**STAFF REPORT 06-26-2019 MEETING****PREPARED BY: A. PHILLIPS****APPLICATION NUMBER: 19-6283****ADDRESS: 1258 WASHINGTON BOULEVARD****HISTORIC DISTRICT: WASHINGTON BOULEVARD****APPLICANT: JAMES FLORA, DETROIT BEER EXCHANGE LLC****PROPOSAL**

With the current proposal, the applicant is seeking the Commission's approval to complete the following work associated with the overall rehabilitation of the building, specifically a tenant build-out for a restaurant at the basement and first level of the existing building. Although Resolution 19-01 allows HDC staff to approve exterior wall penetrations for the installation of ventilation/mechanical, electrical, or plumbing utilities at the side and rear elevations, staff is *unable* to approve the addition of rooftop mechanical units. See attached drawings for locations of the following proposed work items:

PARTIAL  
EAST ELEVATION (ALLEY)

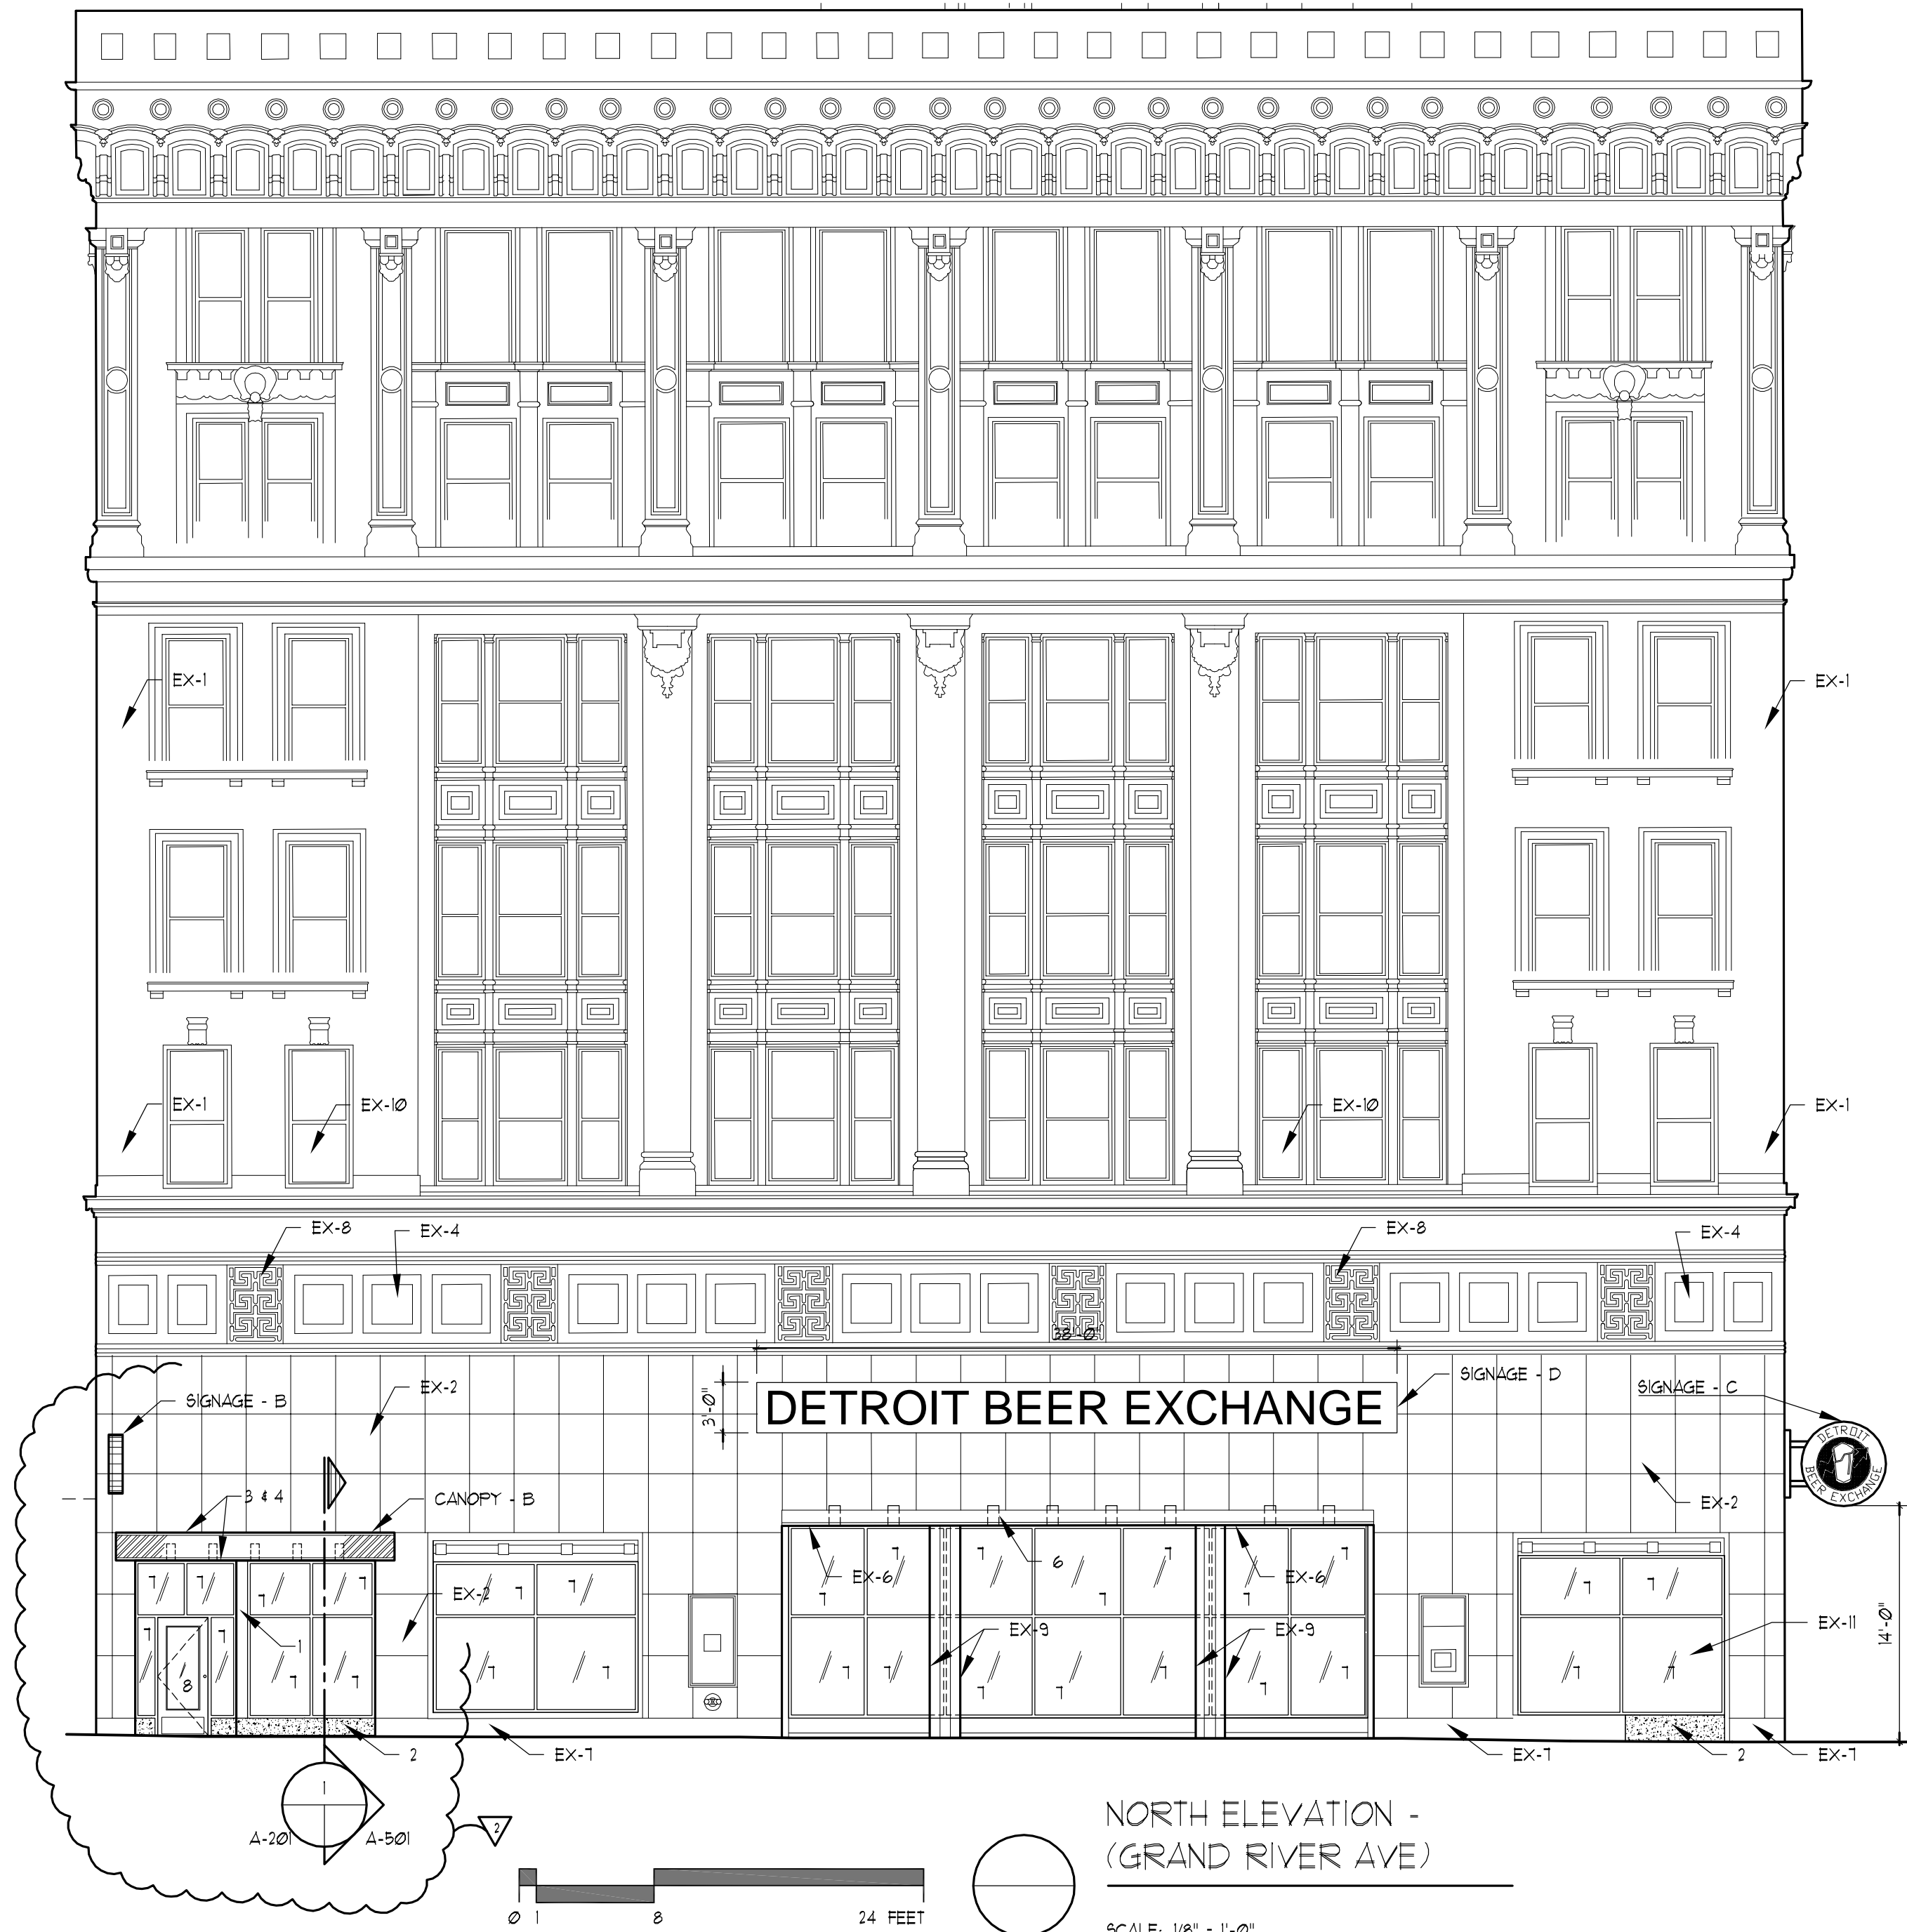
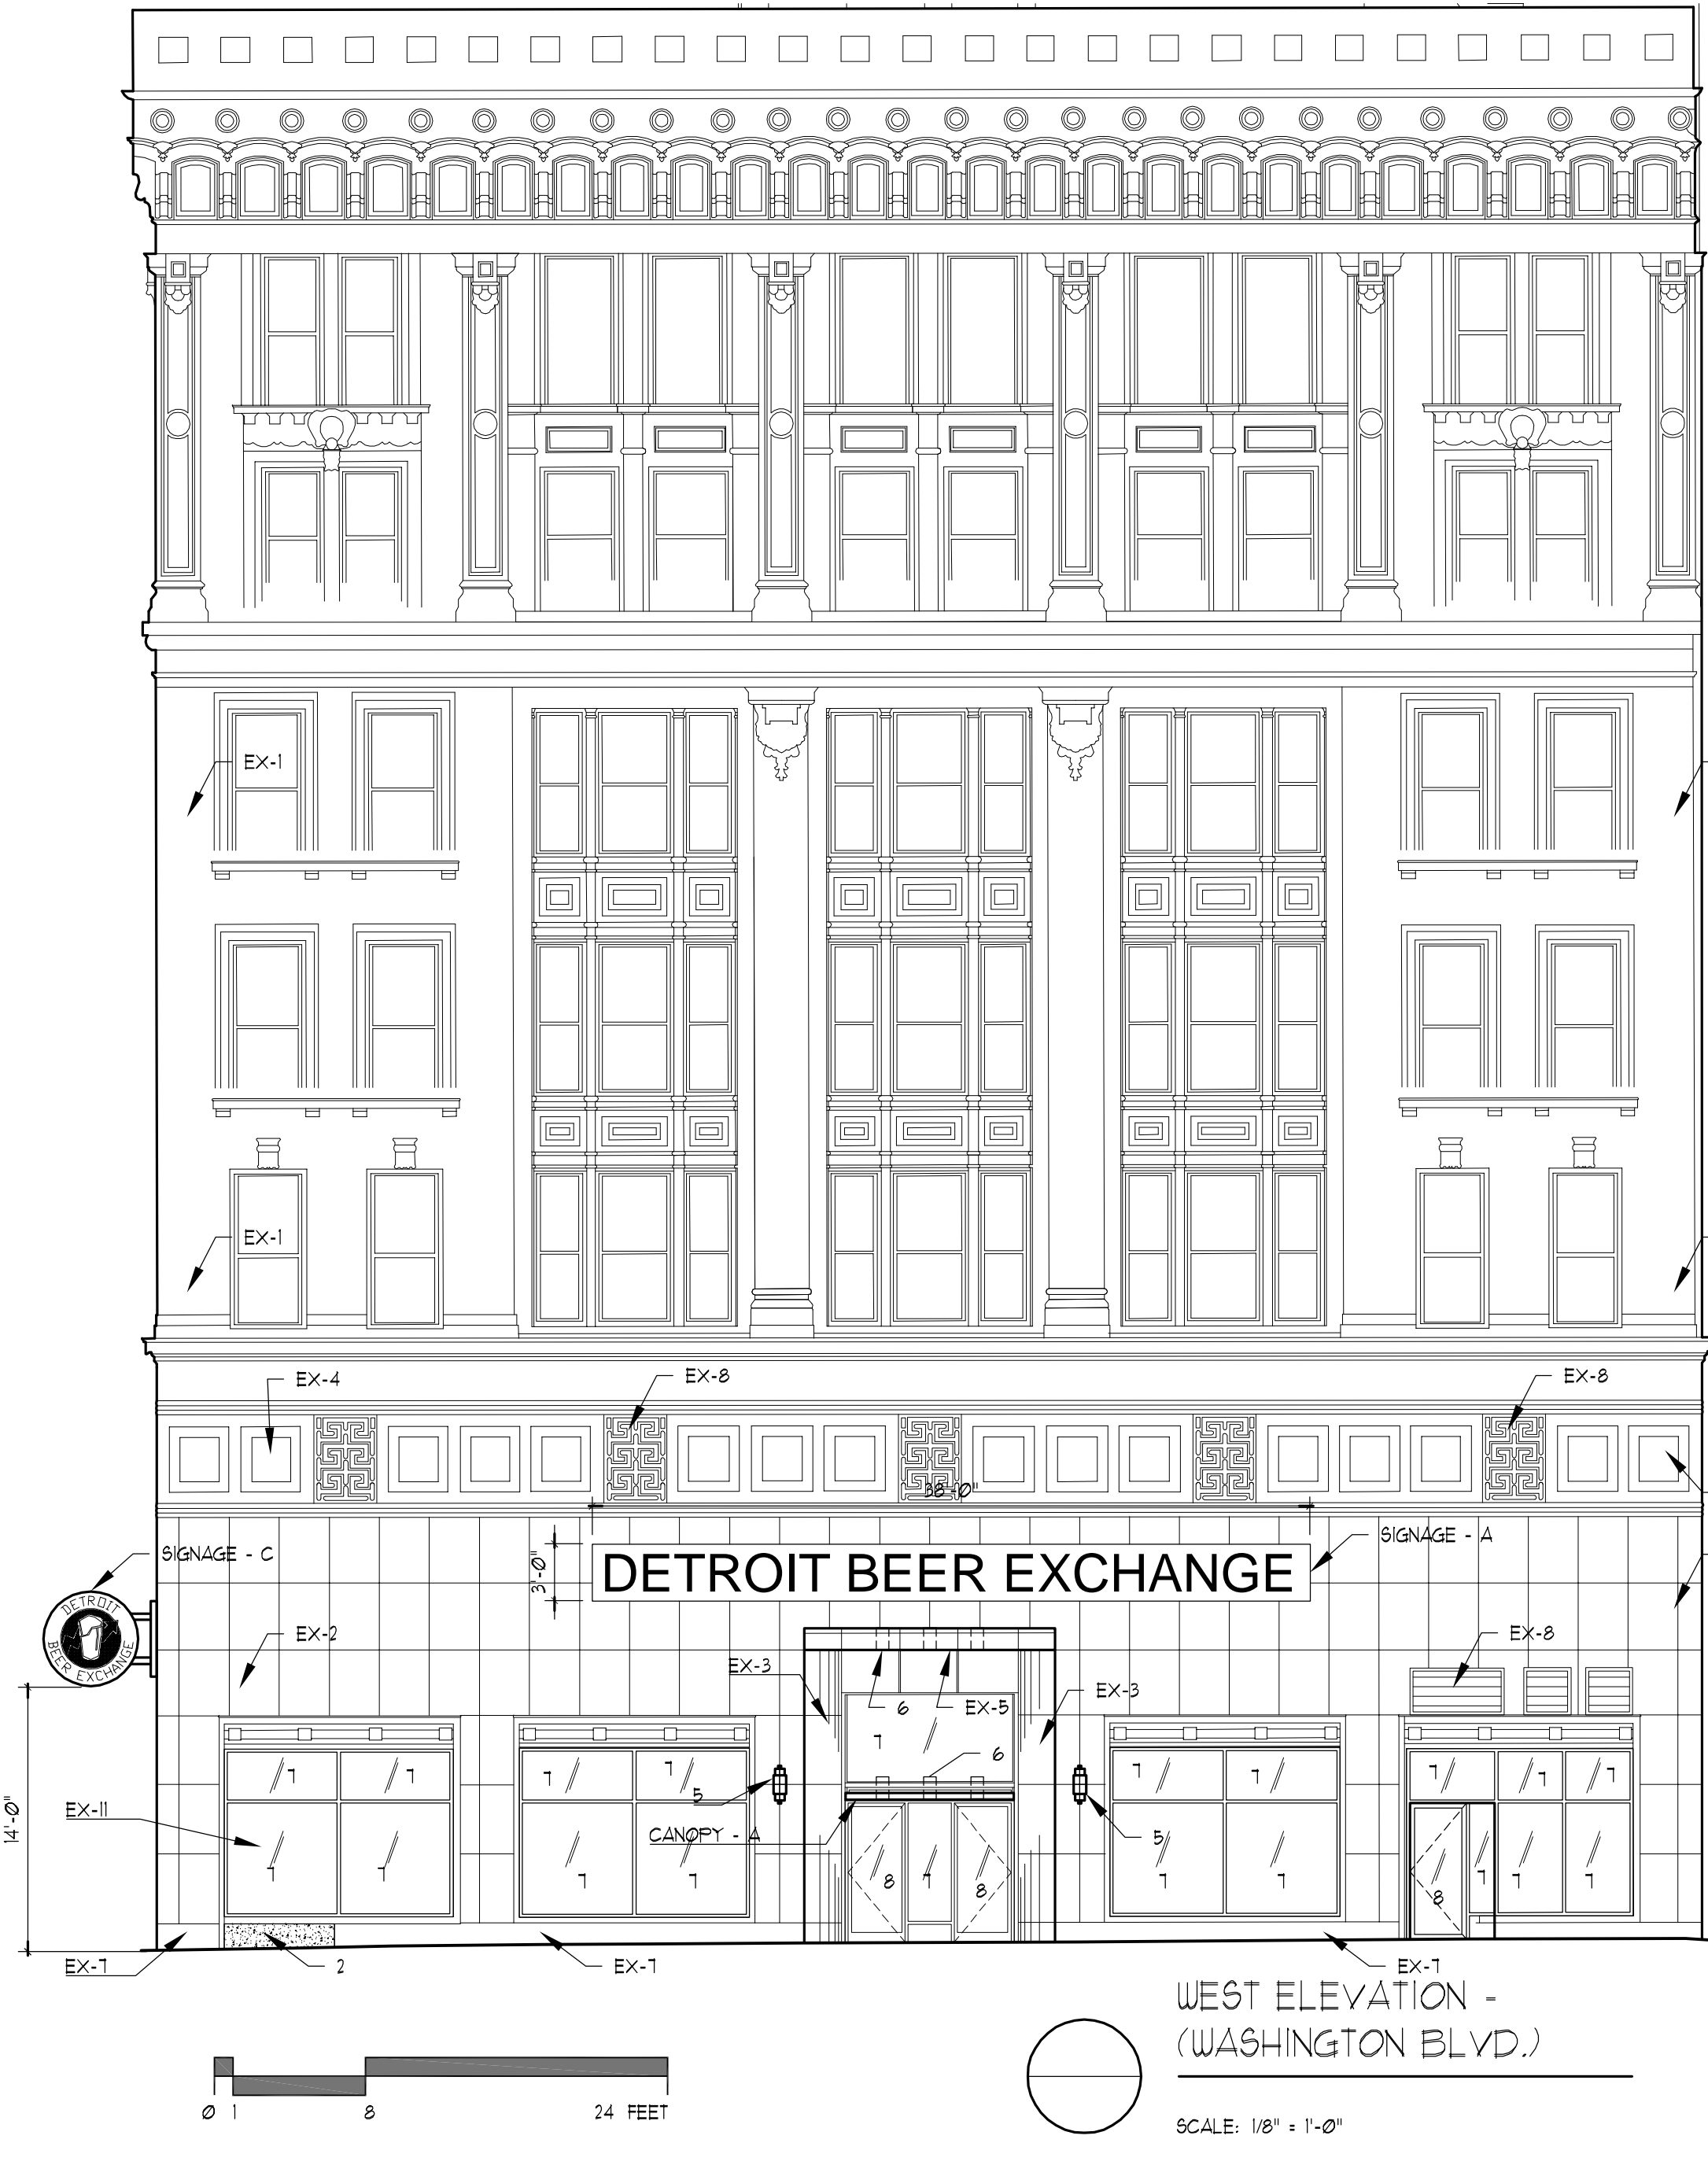
- Installation of (2) new mechanical rooftop units on the existing 2<sup>nd</sup> floor roof. The second floor roof is located at the southeast corner of the building and faces the alley located adjacent to the building on the east side (see attached photos and drawings).
- Installation of (2) wall-mounted air intake ductwork on the east (alley side) façade.
- Installation of (2) exhaust grilles and (1) wall-mounted fan at various locations on east (alley side) façade (see attached drawings for locations).

Staff recommends that the Commission find the project scope, as proposed, to be appropriate as it meets the following Secretary of the Interior's Standards for Rehabilitation
